*City of El Paso – City Plan Commission Staff Report*

**Case No:** SUSU11-00134 Mesquite Trails Unit Eight  
**Application Type:** Major Preliminary  
**CPC Hearing Date:** January 26, 2012  
**Staff Planner:** Kevin Smith, 915-541-4903, [smithkw@elpasotexas.gov](mailto:smithkw@elpasotexas.gov)  
**Location:** East of Joe Battle Boulevard and South of Vista Del Sol Drive  
**Legal Description Acreage:** 23.36 acres  
**Rep District:** 6  
**Existing Use:** Vacant  
**Existing Zoning:** R-3  
**Proposed Zoning:** N/A

### **Mesquite Trails Unit 8 – Major Preliminary**

# ATTACHMENT 3

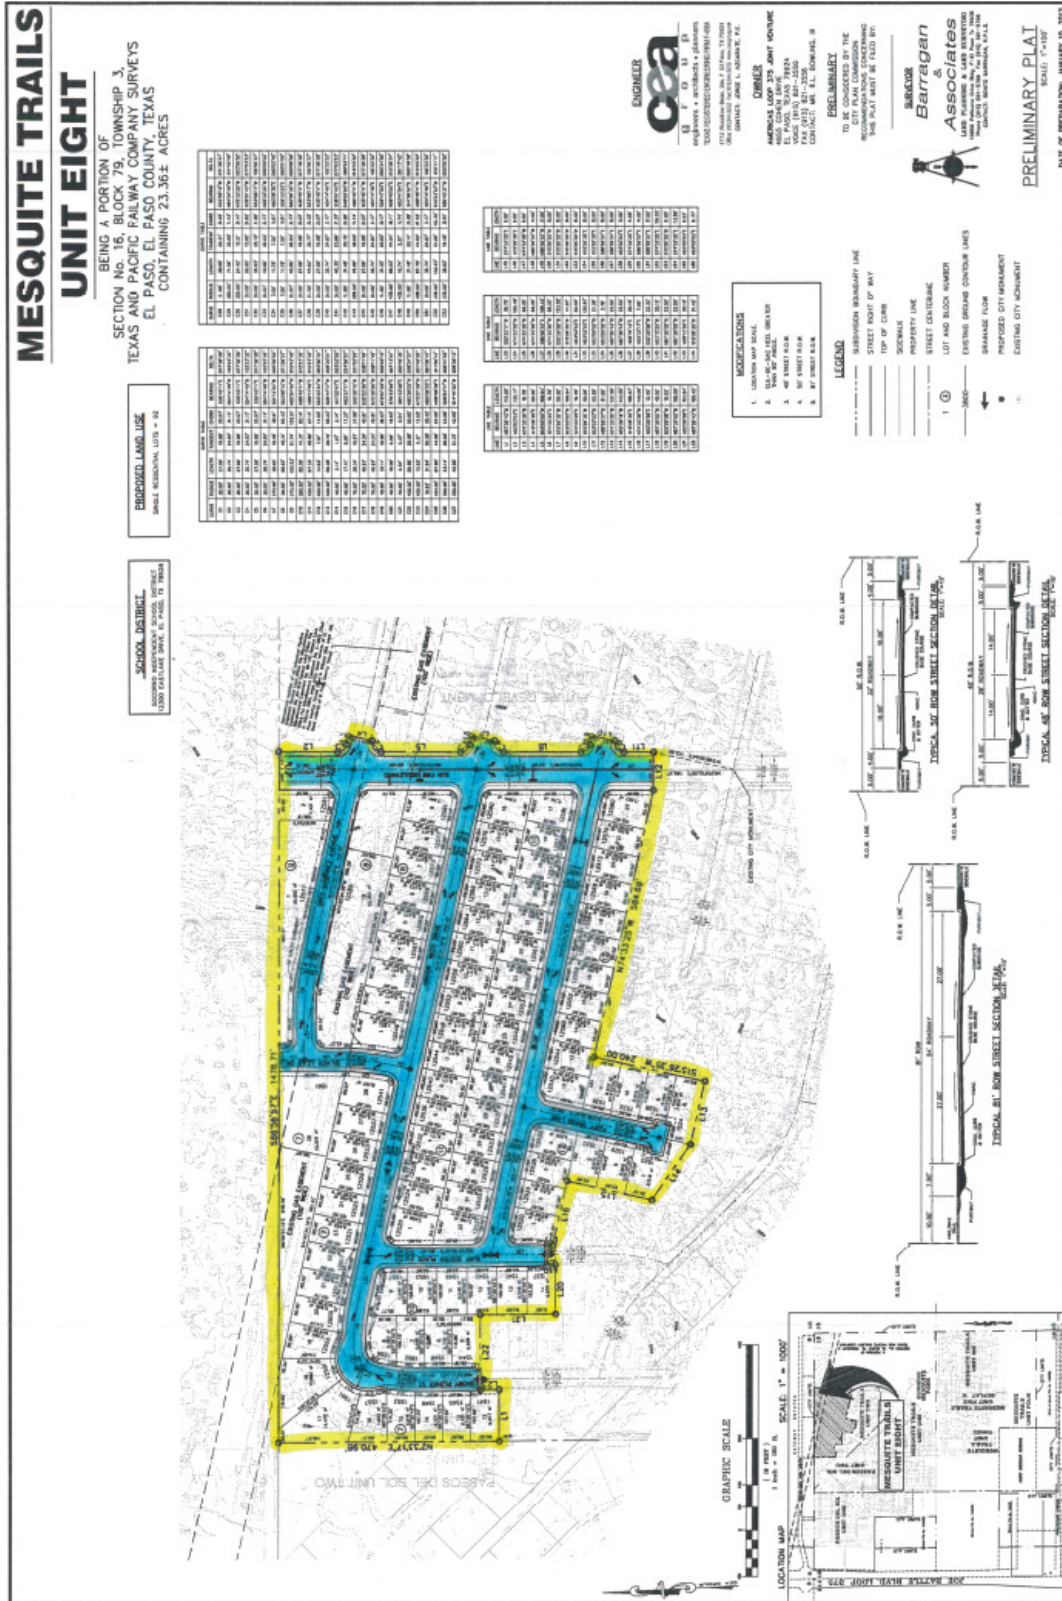
1. The subdivision shall be tied by bearing and distance to either a section corner, a survey line, a grant line, or other known and accepted survey points this tie shall be delineated on the plat.
2. Location Map shall be scaled to 1"=600'

1. Transportation recommends the use of the current street cross sections which include five-foot sidewalks and five-foot parkways.

1. Reduction of Sun Fire (Minor Arterial) width from 84ft. to 81ft. to accommodate a ten foot hike/bike trail within the west parkway as approved in the Paseos Del Sol Land Study.
2. The 48ft cross section on Fluff Grass Ln.
3. Cul-de-sac heel angle greater than 90 degrees at Arrow Weed Drive.

2. Temporary end of road markers or Type III Barricades shall be required at the end of Silver Leaf and Sun Fire.

1. On the preliminary plat identify the ultimate discharge locations for all stormwater runoff. At the improvement plan stage confirm existing conveyance and retention structures have sufficient capacity to handle developed runoff from the proposed subdivision.

2. Show all existing and proposed stormwater infrastructure.
3. At the improvement plan stage mitigate the amount of stormwater runoff on streets by extending the underground storm sewer system to capture street flow at critical points.
4. At the improvement plan stage protect the subject property from damage due to stormwater runoff from the adjacent undeveloped terrain.
5. Incorporate principles of low impact development (such as recessed landscaping, rainwater harvesting, and porous pavements) to reduce the amount of developed stormwater runoff.

1. Parks Department request for all areas shown as "100' Wide Existing Gas Easement" to remain undisturbed.
